Work Order ID 65458

Item Name: Basket Hoop

DESIGN #	DRAWN BY CP	DART AEROSPACE LTD HAWKESBURY, ONTARIO, CANADA	
CHECKED #	APPROVED #	DRAWING NO. D3166	REV. A SHEET 1 OF 1
DATE 02.07.10		TITLE BASKET HOOP	SCALE NTS
A	02.07.10	NEW ISSUE	
A1	04.04.08	38+/-1 WAS 36.0

DRAWING NO. D3166	TITLE BASKET HOOP	REV A1	DART AEROSPACE LTD ENGINEERING ORDER		D.E.O. NO. D3166-A-2	SHEET NO. 1 OF 1	SCALE NTS
DRAWN AJS	CHECKED <i>[Signature]</i>	MFG. APPR. <i>[Signature]</i>	APPROVED <i>[Signature]</i>		DE APPR. <i>[Signature]</i>		
DATE 08.12.11	DATE 08.12.15	DATE 08/12/15	DATE 08/12/16		DATE 08.12.16

D3166-1 BASKET HOOP

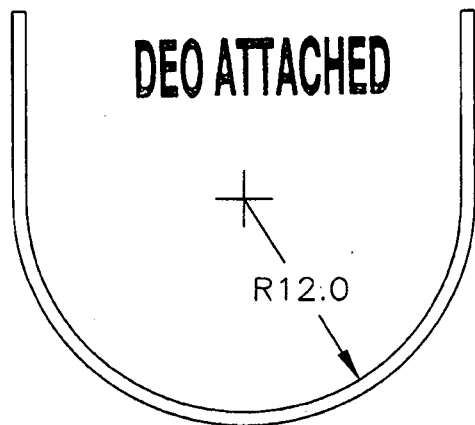
1) MODIFY MATERIAL NOTE FOR D3166-1 AS SHOWN:

- 1) MATERIAL: AISI 304/316 SS, 3/4 X 3/4 X 0.065 WALL SQUARE TUBING,
60.00" LONG
REF. DART SPEC M304TS0.750W.065

- 1) MATERIAL: AISI 304/316 SS SQUARE TUBING,
0.75" x 0.75" x 0.063 WALL, 60.00" LONG
(REF DART SPEC. M304TS0.750W.063)

IS:

WAS:

D3166-3 BASKET HOOP

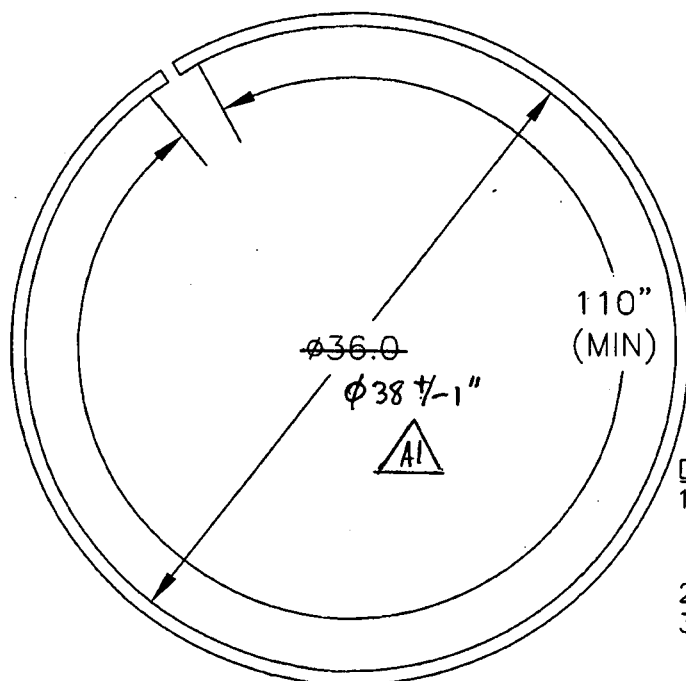
2) MODIFY MATERIAL NOTE FOR D3166-3 AS SHOWN:

- 1) MATERIAL: AISI 304/316 SS, 3/4 X 3/4 X 0.065 WALL SQUARE TUBING,
120.00" LONG
REF. DART SPEC M304TS0.750W.065

- 1) MATERIAL: AISI 304/316 SS SQUARE TUBING,
0.75" x 0.75" x 0.063 WALL, 120.00" LONG
(REF DART SPEC. M304TS0.750W.063)

IS:

WAS:
